Work Order ID 75806

Item Name: Crosstube Low Standard Aft

B	REVISE GENERAL NOTES/PART LIST; UPDATE TO CURRENT STANDARDS; ADD -247B (ZN C4-2, D5-2)	RF	09.09.30
A	NEW ISSUE	CP	07.07.07
REV.	DESCRIPTION	BY	DATE
DESIGN	RF	DART AEROSPACE LTD HAWKESBURY, ONTARIO, CANADA	
DRAWN	RF	DRAWING NO.	REV. B
CHECKED	RF	D212-664-247	SHEET 1 OF 4
MFG. APPR.	RF	TITLE	SCALE
APPROVED	RF	CROSSTUBE (205/212 LOW AFT)	NTS
DE APPR.	RF	COPYRIGHT © 2007 BY DART AEROSPACE LTD THIS DOCUMENT IS PRIVATE AND CONFIDENTIAL. IT IS SUPPLIED ON THE EXPRESS CONDITION THAT IT IS NOT TO BE USED FOR ANY PURPOSE OR COPIED OR COMMUNICATED TO ANY OTHER PERSON WITHOUT WRITTEN PERMISSION FROM DART AEROSPACE LTD.	
DATE	09.09.30

DRAWING NO. D212-664-247	TITLE CROSSTUBE ASS'Y (205 LOW AFT)	REV. B	<b>DART AEROSPACE LTD ENGINEERING ORDER</b>		D.E.O. NO. D212-664-247-B-1	SHEET NO. SHEET 1 OF 1	SCALE NTS
DRAWN <i>qp</i>	CHECKED <i>ASS</i>	MFG. APPR. <i>AB</i>	APPROVED <i>WD</i>		DE APPR. <i>W</i>		
DATE 11.07.15	DATE 11.07.20	DATE 11.07.21	DATE 11/07/21		DATE 11.07.21

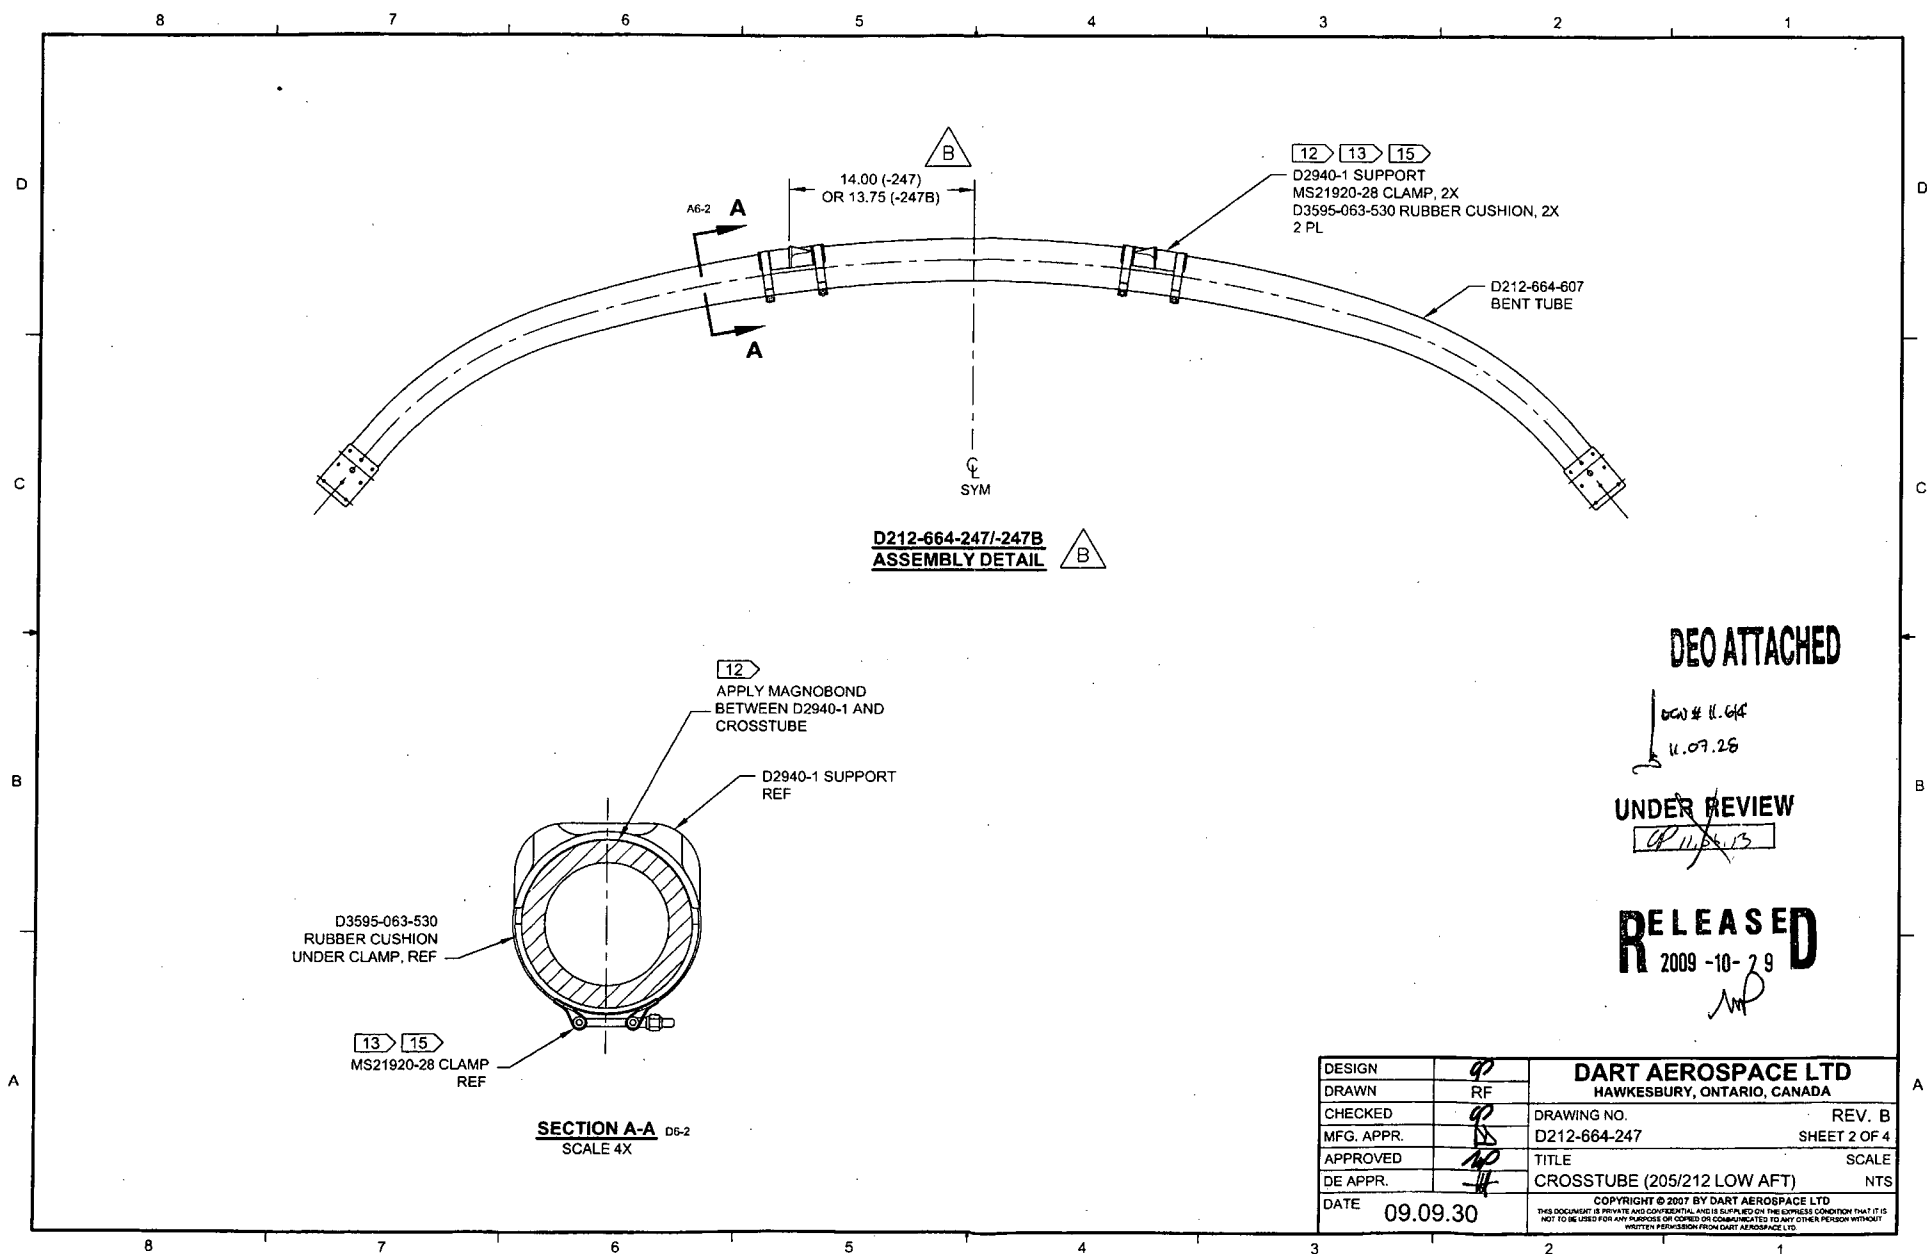
REPLACE MAGNOBOND WITH PROSEAL.

IS:

Item	Qty -247	Qty -247B	Part Number	Description
9	A/R	A/R	PROSEAL 890 B-2	SEALANT, AMS-S-8802 CLASS B-2

WAS:

9	A/R	A/R	MAGNOBOND 6398	ROCKWELL SPECIFICATION RBO-120-023 ADHESIVE (TEXTRON/BELL SPEC. 299-947-100, TYPE II, CLASS 2 ADHESIVE)
---	-----	-----	----------------	---

NOTE 12 & 15, SHEET 1 IS AMENDED AS FOLLOWS:

- 12) TO INSTALL D2940-1 SUPPORT: ABRASE MATING SURFACE OF SUPPORT AND CROSSTUBE WITH 180-GRIT SANDPAPER AND REMOVE RESIDUE WITH MEK (OR EQUIVALENT). APPLY A 0.04" TO 0.07" THICK LAYER OF PROSEAL 890 CLASS B-2 (OR AMS-S-8802 CLASS B-2) SEALANT TO MATING SURFACE OF SUPPORT.
- 15) TORQUE CLAMPS 80 TO 100 IN-LB. ENSURE AT LEAST 1.5 THREADS SHOWING IN SAFETY AND THAT NUT HAS NOT BOTTOMED-OUT AFTER TORQUING. **PRIOR TO PACKAGING, RE-CHECK TORQUE ON CLAMPS AFTER PROSEAL 890 SEALANT HAS CURED FOR 72 HOURS.**

- 12) INSTALL D2940-1 SUPPORT USING 0.03" TO 0.06" THICK LAYER OF MAGNOBOND 6398 TO THE SURFACE OF D2940-1 THAT WILL BE IN CONTACT WITH THE CROSSTUBE PER QSI 015. LET CURE FOR 12 HOURS AFTER INSTALLATION AND PRIOR TO PACKAGING.
- 15) TORQUE CLAMPS 80 TO 100 IN-LB. ENSURE AT LEAST 1.5 THREADS SHOWING IN SAFETY AND THAT NUT HAS NOT BOTTOMED-OUT AFTER TORQUING.
